CMD 25-H12-REF5 CNSC Staff Submission

Reference Package 5 for CMD 25-H12 CNSC Staff Submission on NexGen Energy Ltd. Licence Application to Prepare Site and Construct the Rook I Project

Written Submission from
Ya'thi Néné Land and Resource Office

In the Matter of;
NexGen Energy Ltd. Rook I Project Description

Figure 3: Map of site infrastructure, surface water flows around the mine (solid blue lines) and location of water intake from and effluent discharge into Patterson Lake (NexGen, 2022)

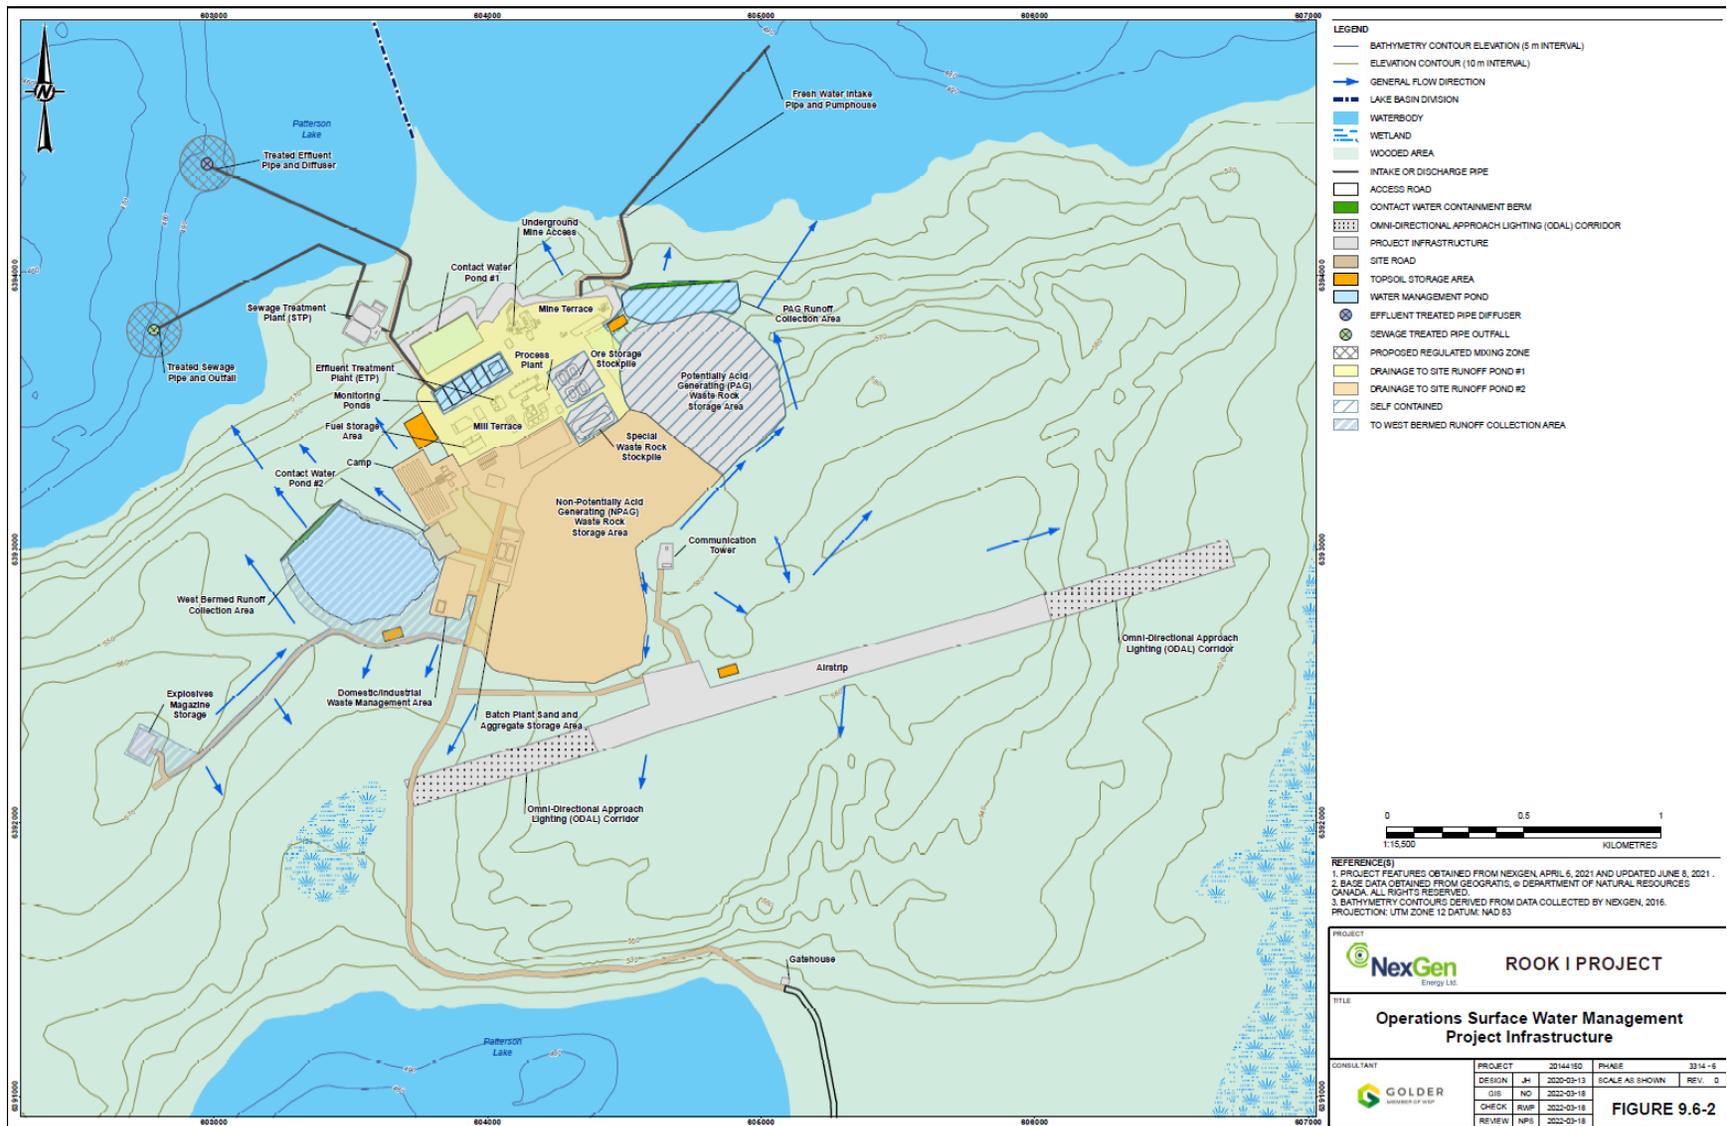
- NexGen expects cobalt and copper to remain elevated above water quality guidelines for many hundreds or perhaps thousands of years. NexGen and the Crown must demonstrate that this significant impact will be minimized to the maximum extent and properly accommodated
- Available data indicates that waste rock from the Project is much more likely to cause acid rock drainage and metal leaching than what BNDN previously understood.
- NexGen has underestimated how sensitive Patterson Lake is to the addition of metals and acidity from the Project, and has not considered how acid rain caused by oil sands emissions may cause cumulative effects on Patterson Lake that may negatively affect water quality far downstream

Figure 5. LSA/RSA for fish habitat (NexGen EIS, 2022)

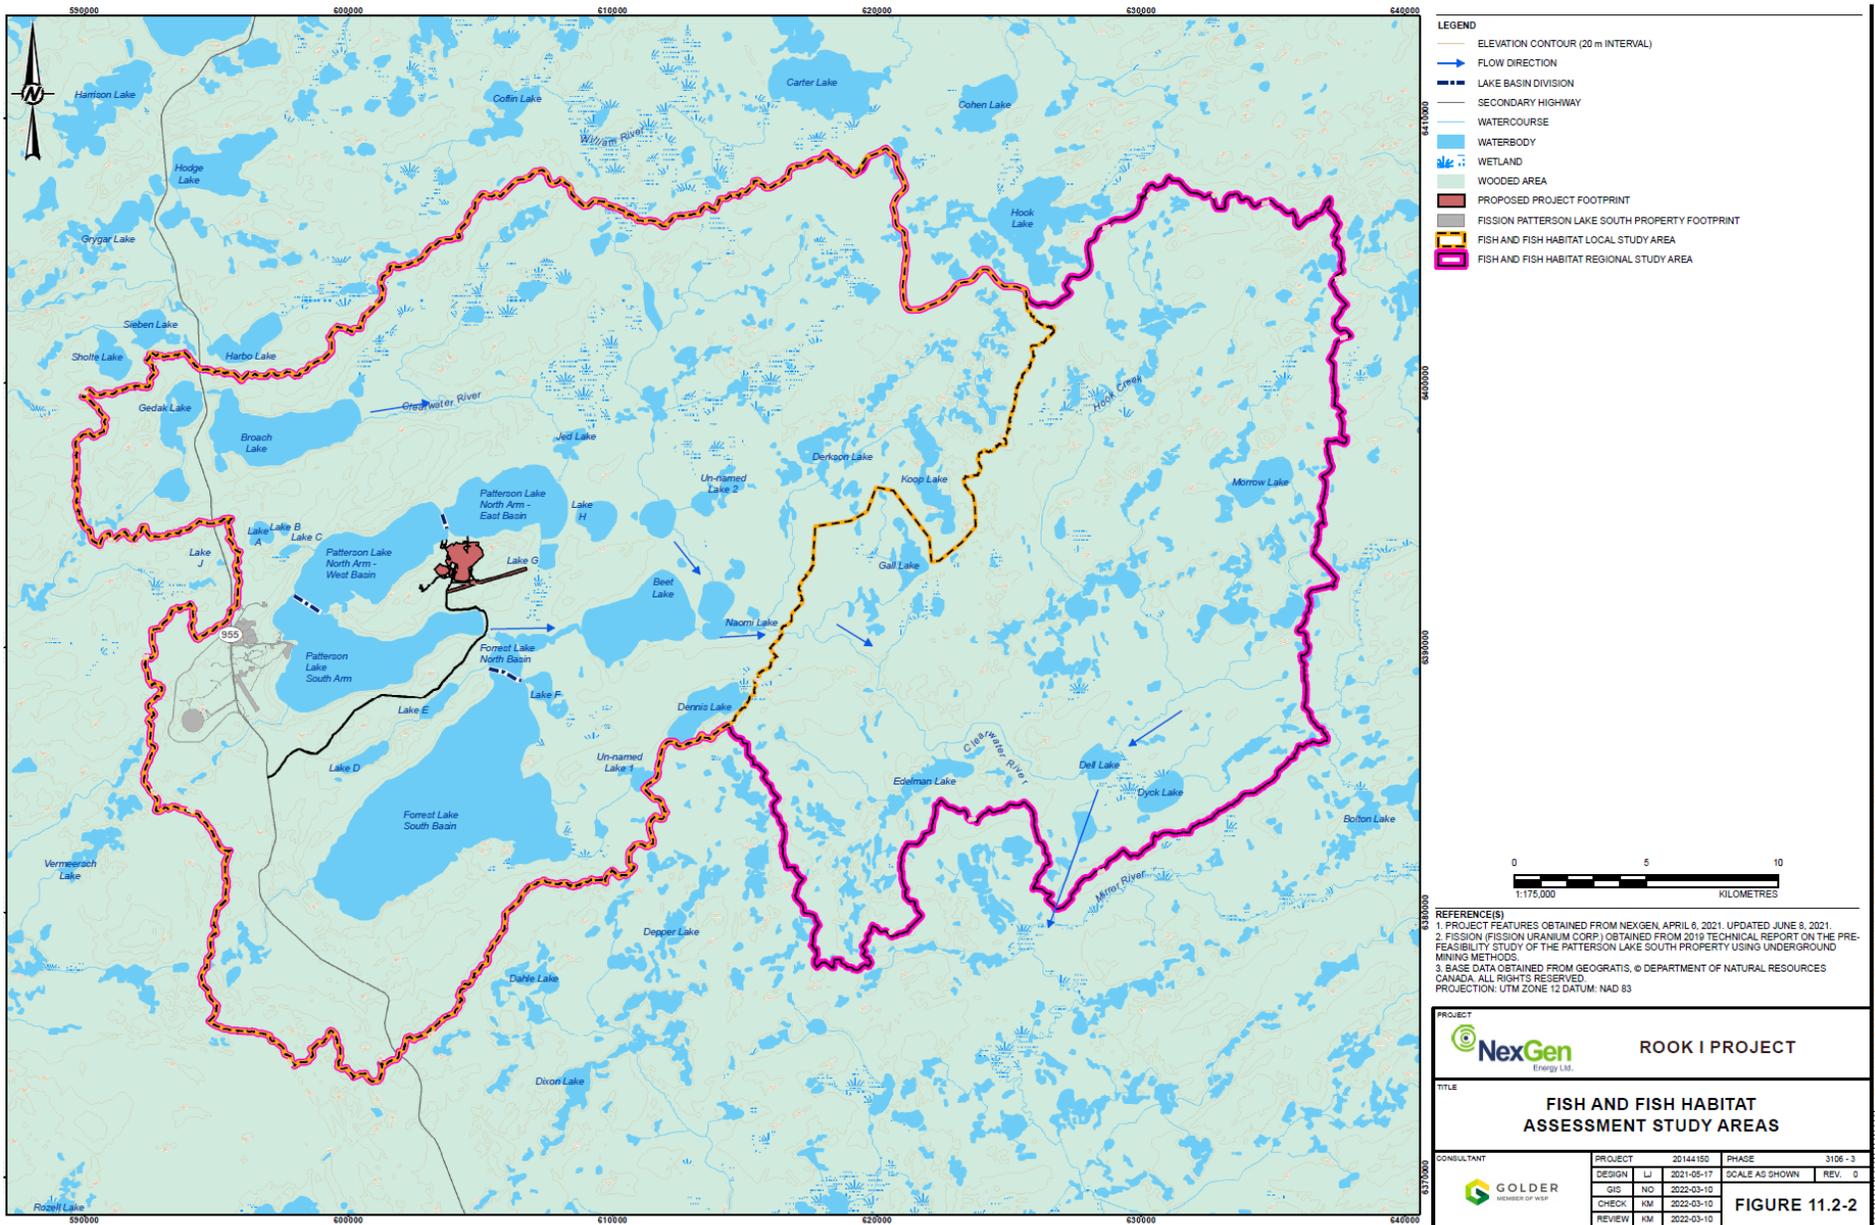
The Fish and Fish Habitat LSA is 685 km² and includes portions of the Clearwater River watershed from its headwaters to the outlet of Naomi Lake (Figure 5). The LSA was selected to evaluate potential direct effects and local indirect effects from the Project. The RSA includes this area and all the areas draining to the Clearwater River through its confluence with the Mirror River (1,076 km²). The RSA was selected to assess the maximum predicted direct and indirect effects of the Project, along with cumulative effects of other reasonably foreseeable projects. These study areas are the same as those used for hydrology and surface water quality.
